Product Safety Recall

N202322233 Seat Belt May Not Be Properly Attached

Release Date: January 2021

Revision: 01

5618244

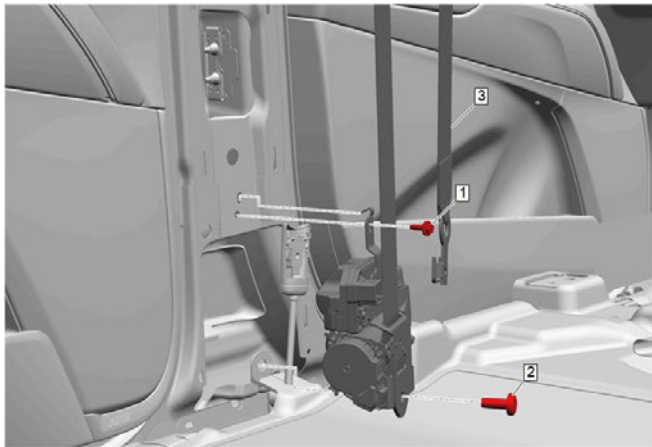
1. Remove the center pillar lower trim panel. It is not necessary to disconnect the seat belt from the seat belt anchor plate tensioner. Refer to *Center Pillar Lower Trim Panel Replacement* in SI.

2. Remove and discard the lower retractor bolt (2).
3. Install the new retractor mounting bolt. Refer to the note above for installation details. Tighten the new service bolt to 45 N.m (33 lb. ft).
4. Reinstall the center pillar lower trim panel. Refer to *Center Pillar Lower Trim Panel Replacement* in SI.

Second Row Retractor Mounting bolt (2)

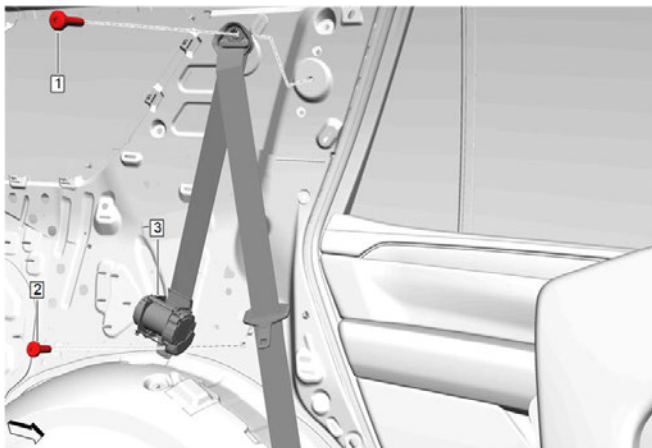
3. Remove the second or third row seat belt retractor bolt as required. Discard the bolt.
4. Install the new retractor mounting bolt. Refer to the note above for installation details. Tighten the new service bolt to 45 N.m (33 lb. ft).
5. Reinstall the quarter lower rear trim panel. Refer to *Quarter Lower Rear Trim Panel Replacement* in SI.
6. Reinstall the rear compartment floor stowage compartment. Refer to *Rear Compartment Floor Stowage Trim Compartment Replacement* in SI.

Third Row Seat Belt Anchor Bolt Replacement

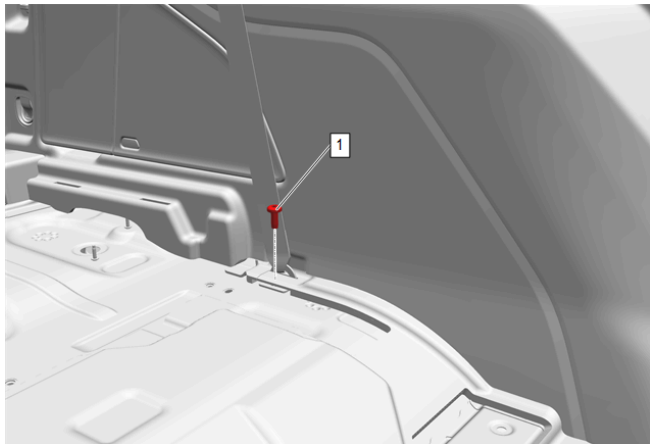
2. Locate the third-row seat belt anchor bolt (1). Remove and discard the bolt.
3. Install the new seat belt anchor bolt. Refer to the note above for installation details. Tighten the new service bolt to 45 N.m (33 lb. ft).
4. Reinstall the third-row seat. Refer to *3rd Row Seat Removal and Installation* in SI.
